Subject: Special permit to develop a 596+ sq. ft. restaurant with two drive-up windows  
(P87-046)

Location: Northeast corner Rimmer Avenue and Northgate Boulevard

**APPLICATION:** Special permit to develop a 596+ sq. ft. restaurant with two drive-up service windows (see 3-D-8)

APPLC. NO. P87-046 MEETING DATE February 12, 1987 ITEM NO 14

EXHIBIT D

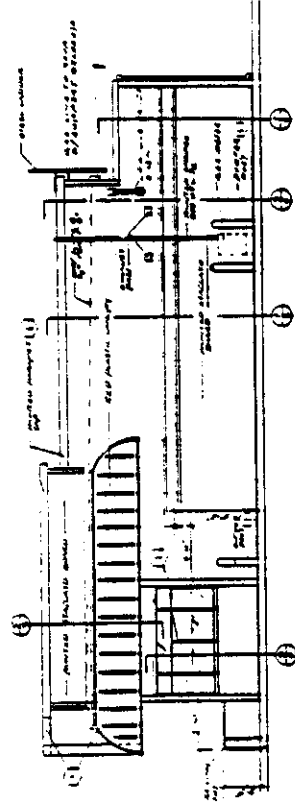
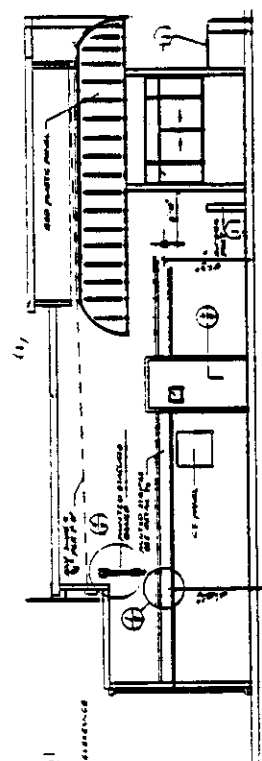
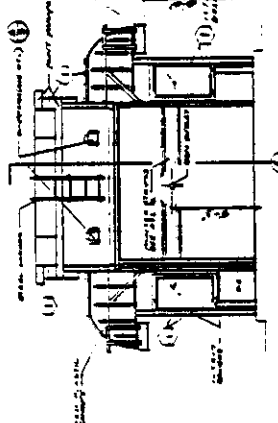
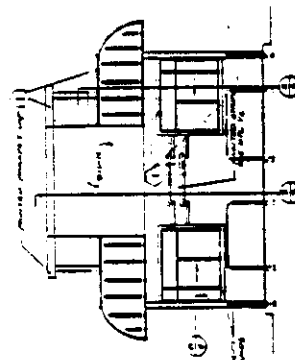
The proposed Rally's building is proposed to have a stucco exterior painted beige with a red accent stripe around the building (Exhibit D). Red plastic awnings are proposed to cover the two drive-up windows and two walk-up windows. An attached identification sign is proposed for the west elevation. Staff finds the proposed elevations to be stark and lacking in interest. More design variation and detail is needed.

EXHIBIT C

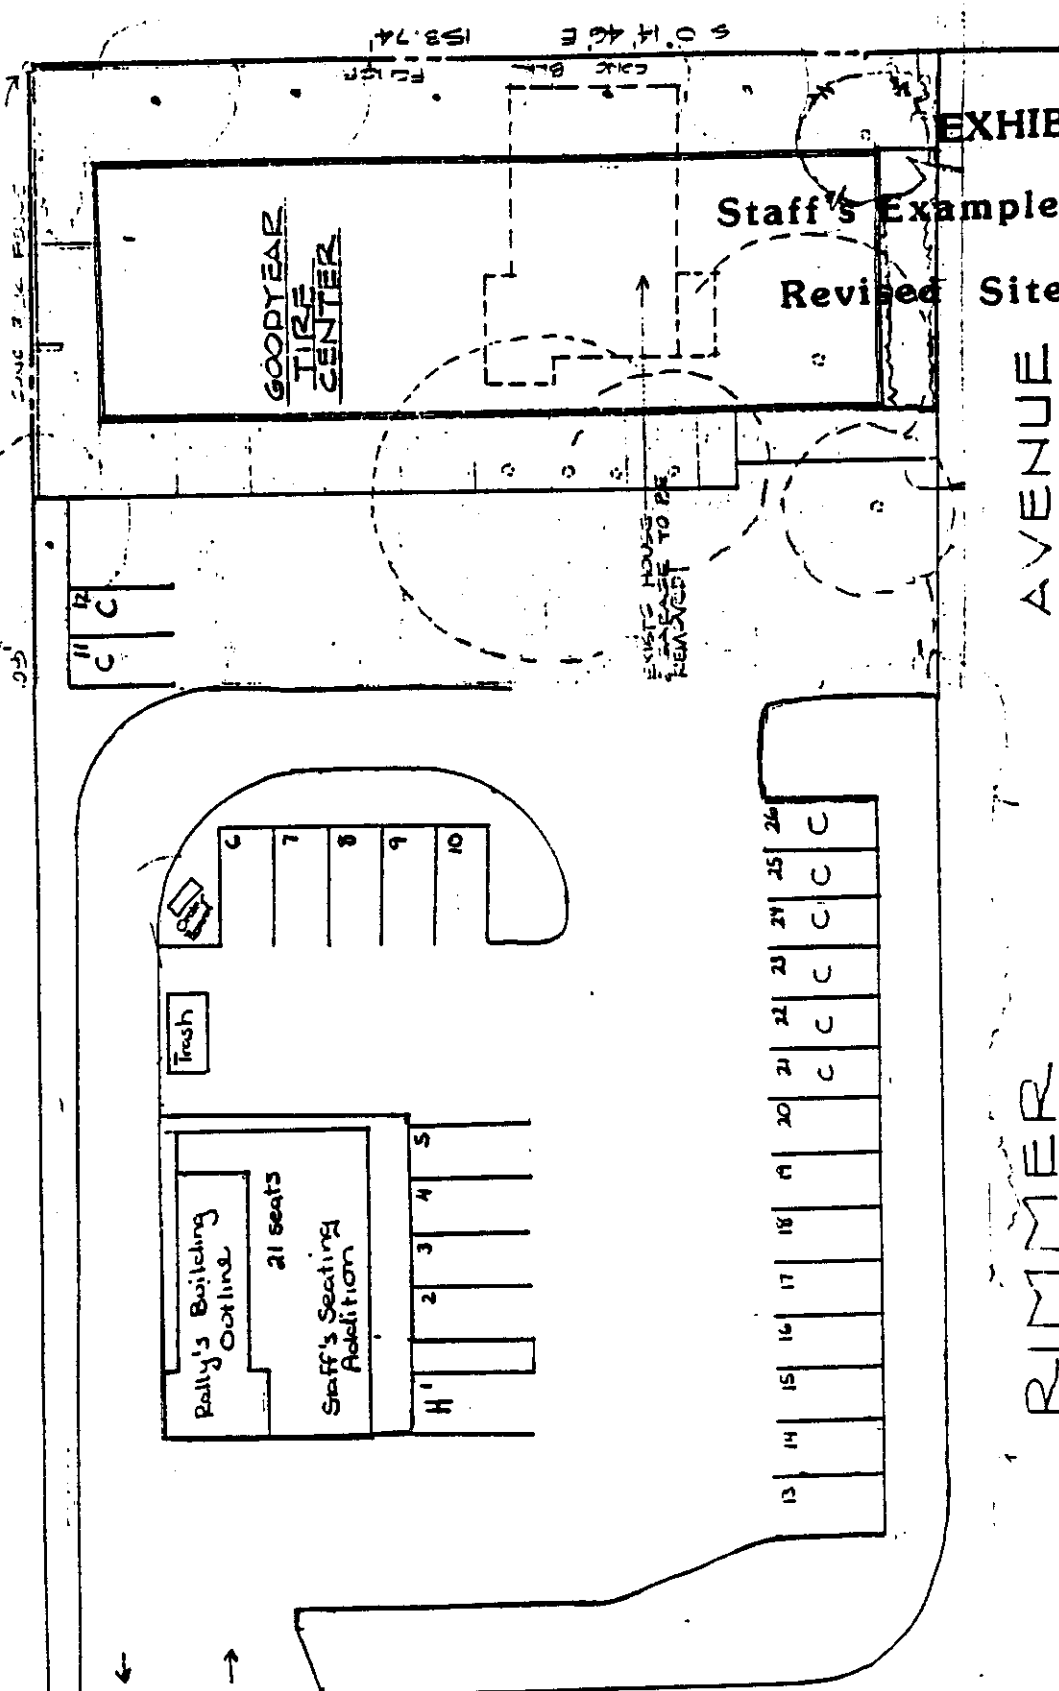
Planning Staff met with the applicant and recommended that the site plan be redesigned to eliminate one drive-up service window, add an indoor seating/dining area, reduce the amount of paving and solve the existing circulation problems. The applicant submitted a revised site plan redesigning the circulation pattern and adding an outdoor seating area and landscaping (Exhibit B). Planning and Traffic Engineering Staff find this site plan to be unacceptable in that: inadequate parking is provided for the number of seats indicated; indoor seating is not provided; adequate stacking distance for vehicles is not provided; drive-through lane should accommodate a minimum of six vehicles; and there are still circulation problems with the proposed design. Planning and Traffic Engineering Staff find that the project should be redesigned to eliminate one drive-up service window and add indoor seating (Exhibit C). Staff, therefore, recommends denial of the applicant's request.

## Applicant's Revised Site Plan

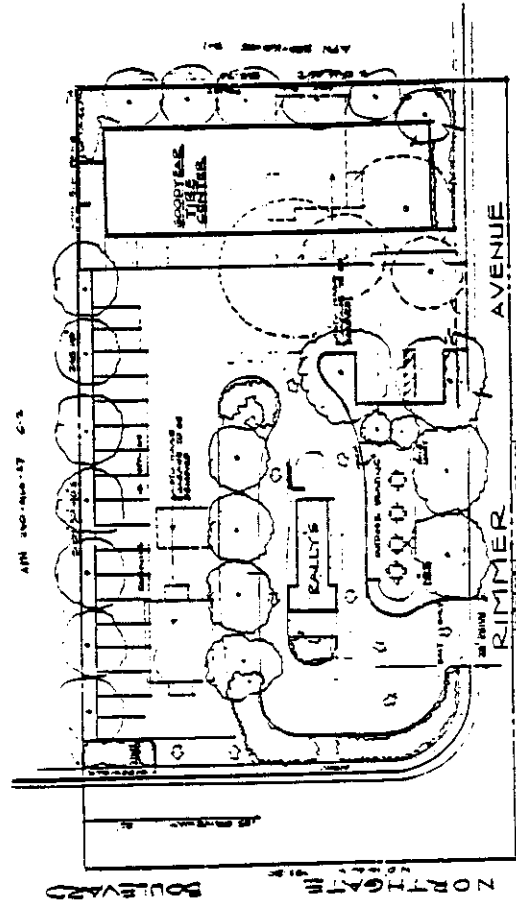
Staff, however, continues to find that the proposed restaurant with two drive-up service windows is inappropriate for the site in that there is too much paving on the subject site and there are several problems with the proposed circulation pattern. The surrounding area is developing with several retail commercial uses which could benefit with an indoor seating area. Planning and Traffic Engineering staff find that the project should be redesigned to eliminate one drive-up service window and add indoor seating (Exhibit 1). Staff, therefore, recommends denial of the applicant's request.
